CITY OF ALBUQUERQUE

**Re: Lot 12 Block 6 Volcano Cliffs Unit 5
8009 Victoria Dr. NW
Grading & Drainage Plan
Engineer's Stamp dated: 9-12-17 (E10D037)**

**Lots 12, Block 6
Volcano Cliffs Subdivision, Unit 5
GRADING PLAN**

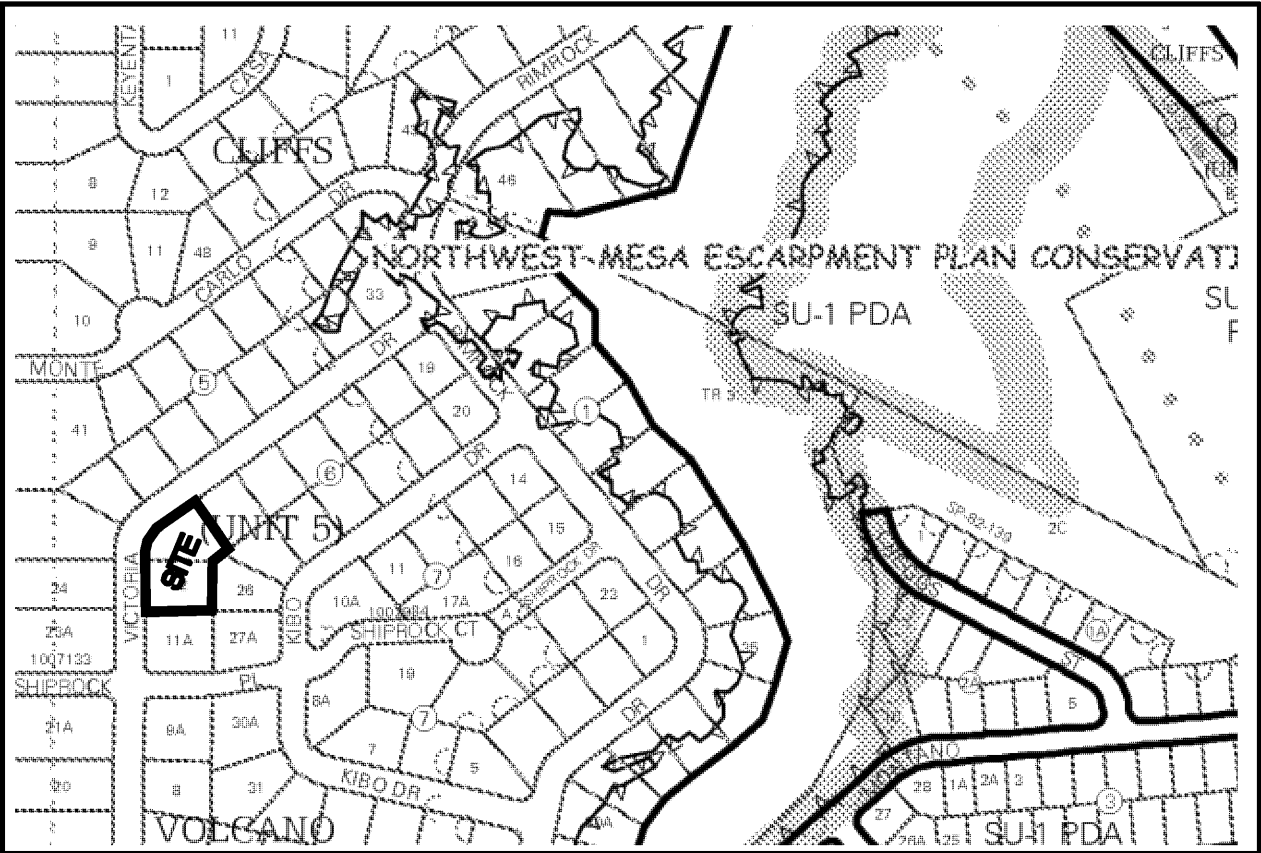
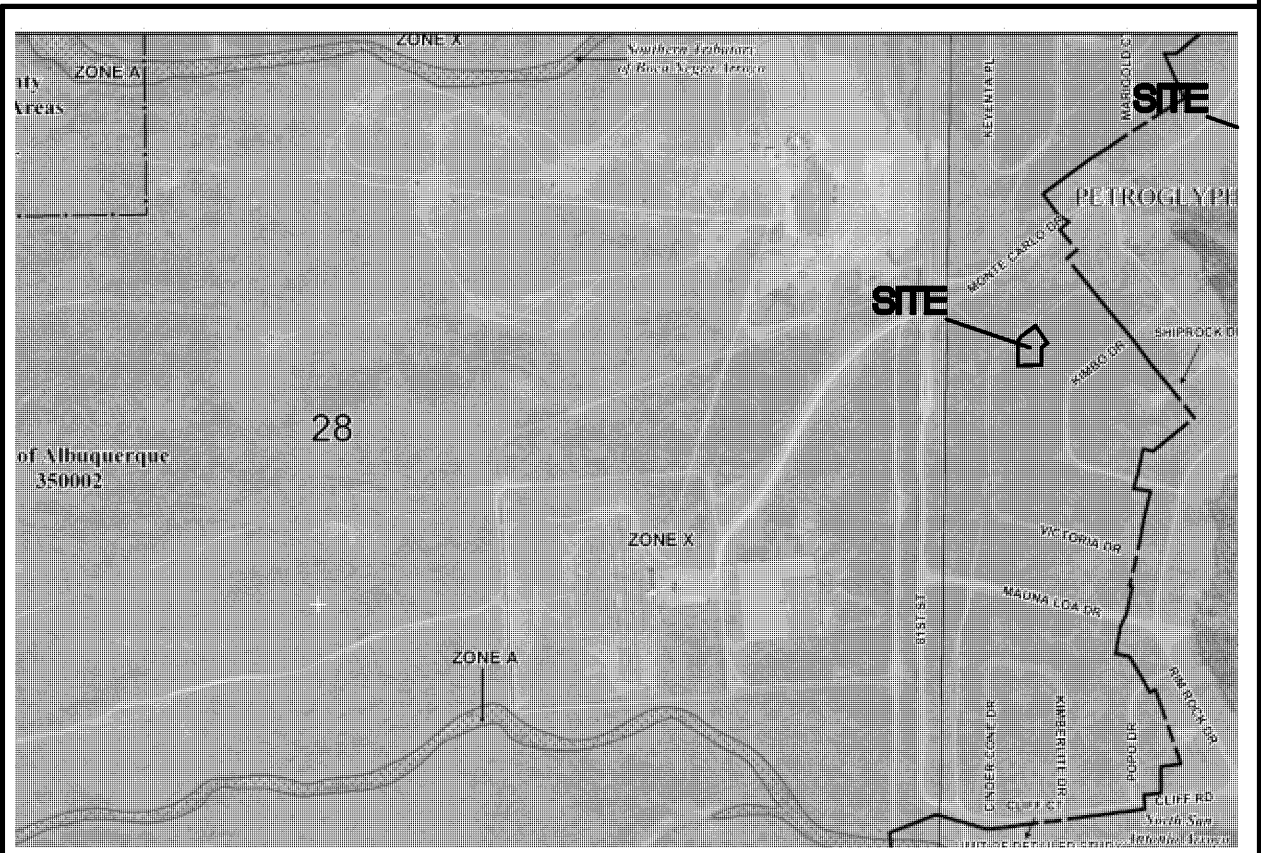
Reiterate to the Owner/Contractor that a separate permit for a garden/retaining wall must be obtained, with the approved G&D plan dated 9/12/17.

Prior to Certificate of Occupancy release, Engineer Certification per the DPM checklist will be required.
